P 516071-B

## ON-SITE SEWAGE DISPOSAL SYSTEM HOWARD COUNTY HEALTH DEPARTMENT BUREAU OF ENVIRONMENTAL HEALTH

ADDRESS: 11719 Janney Court PROPERTY OWNER: Kevin O'Malley

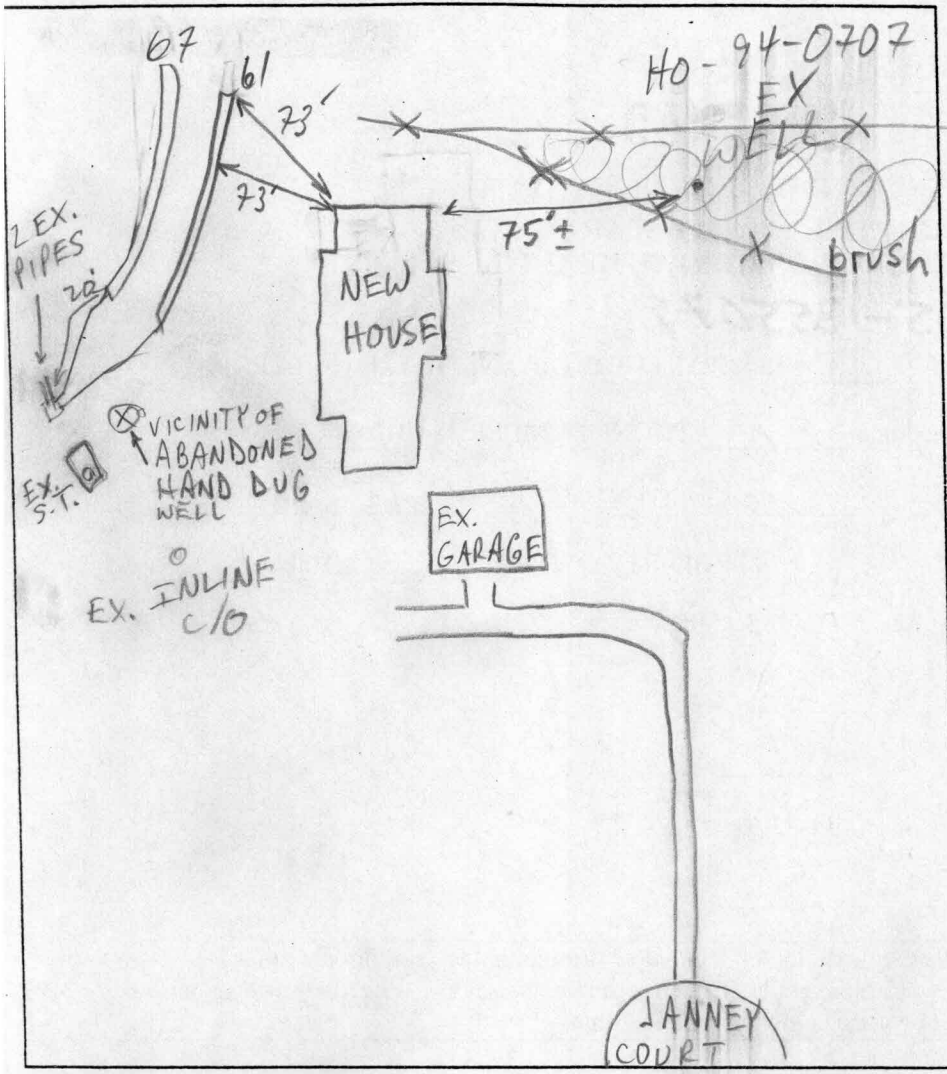
PRE-CONSTRUCTION INSPECTION: 10/30/01<sup>AM</sup> OK TO START; INSTALLER WANTS TO ADD

(2) 60' TRENCHES - OK (MR)

INSPECTION COMMENTS: 10/30/01 PM OK TO COVER MR
